## CONDITIONS OF APPROVAL:

## Open Issues: 33

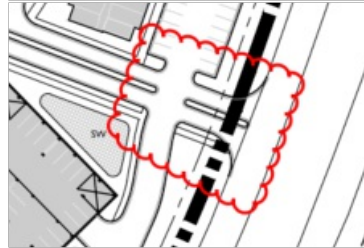
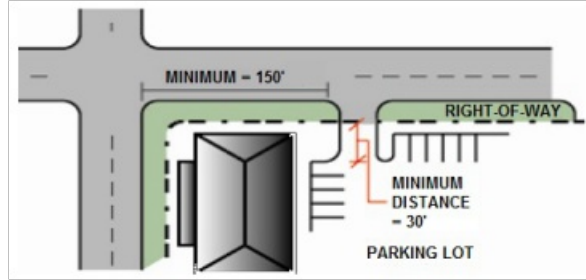
kevin.long@franklintn.gov

The accompanying exhibits depicting roadway improvements do not adequately address the previous comment: "Provide an additional sheet showing conceptually any off-site improvements to be included with this development, including the extents of the improvements along Huffines Road."

Applicant shall provide an additional ROW and Access sheet in the plan set showing conceptually all off-site improvements associated with this development and required by the traffic study. These should be shown as functional exhibits only, without dimensions or engineering design. (The exhibits included with this submittal are too detailed for this stage of approval.) Include the section of Huffines Road from the intersection of Liberty & Huffines to the northern property line and the improvements proposed on Carothers Parkway. The engineering design of roadway elements at the site plan stage will be required to meet all appropriate transportation design standards as set forth by the City, TDOT, AASHTO, et. al.

### 73. Carothers Parkway Turn Lane Improvements Exhibit

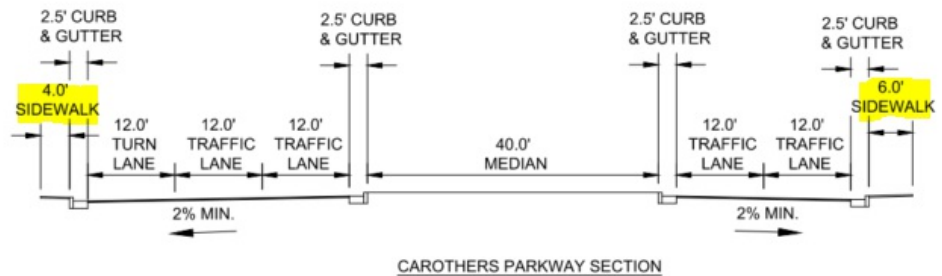
joe.marlo@franklin.tn.gov The following is a newcomment based on newinformation shown (Exhibit).

Applicant to revise the Carothers Parkway Section to have a 6-foot grass strip behind curb, 6-foot sidewalk (west side) / 12-foot multi-use path (east side), and 2-foot grass strip behind sidewalk to edge of ROW. Include the revised section on a sheet within the Development Plans.

#### 6. Sanitary sewer

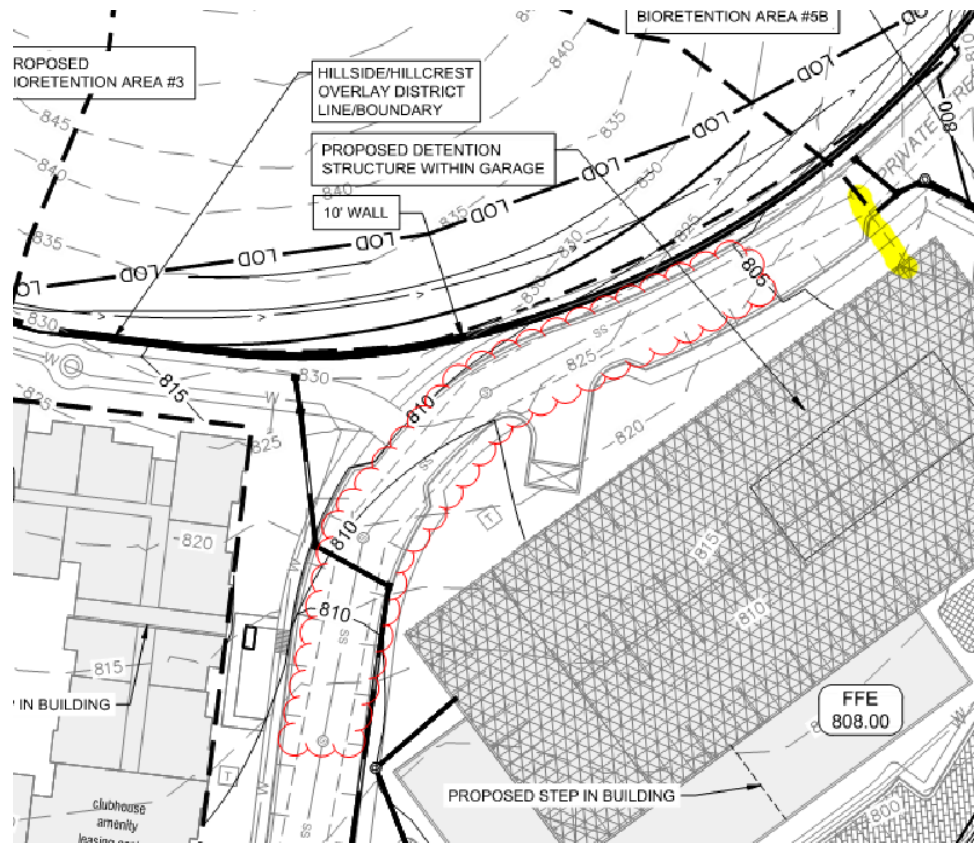
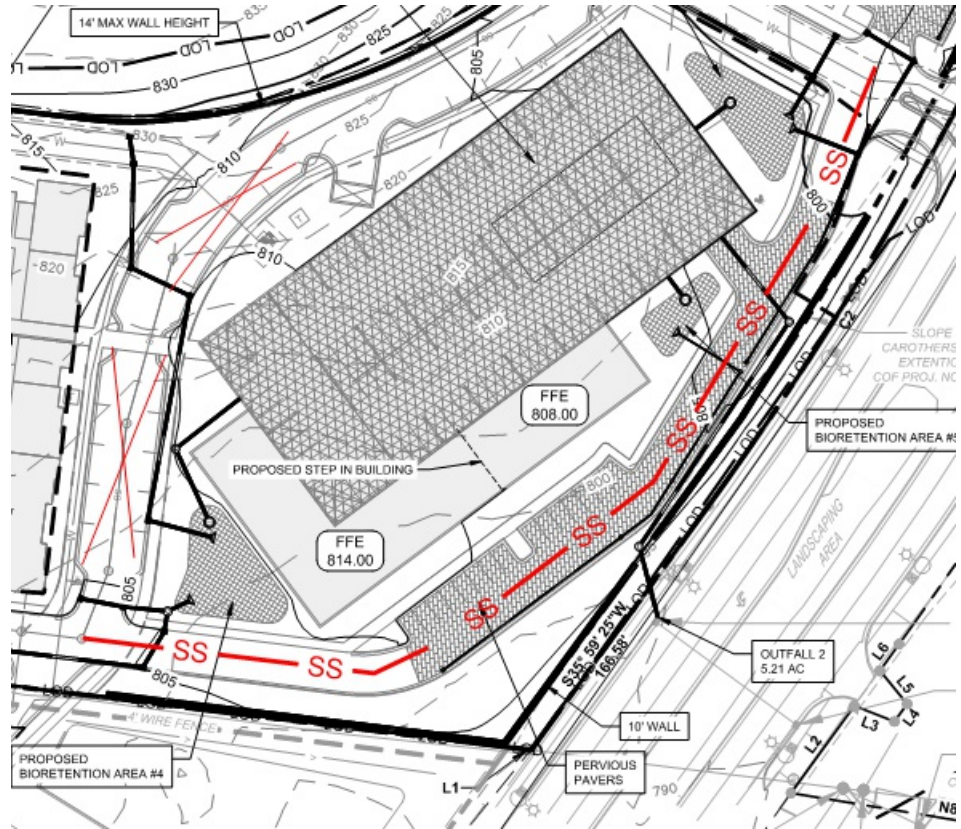
[ben.mcneil@franklinton.gov](mailto:ben.mcneil@franklinton.gov) The applicant shall note any depths that will be greater than 10' on the development plan. The contours are not clear on the depths of the proposed sanitary sewer.

[ben.mcneil@franklinton.gov](mailto:ben.mcneil@franklinton.gov) As it appears to be on the development plan, the sanitary sewer main must be at least 20' in depth to serve the northern hotel. In any areas where the sanitary is 12' or greater, the Water management department will not accept the sanitary sewer at this depth, at site plan the applicant shall revise the utility layout to provide sanitary sewer at an acceptable depth. All water management specs shall be met.

The applicant did not address the issue of the sewer depths. water management has concerns that the depths will not change at site plan. Therefore, the sanitary sewer layout shall be revised to the original sewer location. Minimum depths shall be met and all design guidelines followed for the sewer layout. The snip below shows the original layout, if the applicant has questions they may contact Franklin water.

[greggamble209@gmail.com](mailto:greggamble209@gmail.com) Per discussion with Ben McNeil, formal sewer plan and profiles will be provided at site plan stage. A note has been added to the Utility Plan Sheet C5.1 stating that the sanitary sewer will be installed at minimal depth where possible.

[greggamble209@gmail.com](mailto:greggamble209@gmail.com) Prior to/during site plan stage, the sanitary sewer layout will be designed to keep the pipe at a minimum depth or alternate sanitary sewer connections will be required.
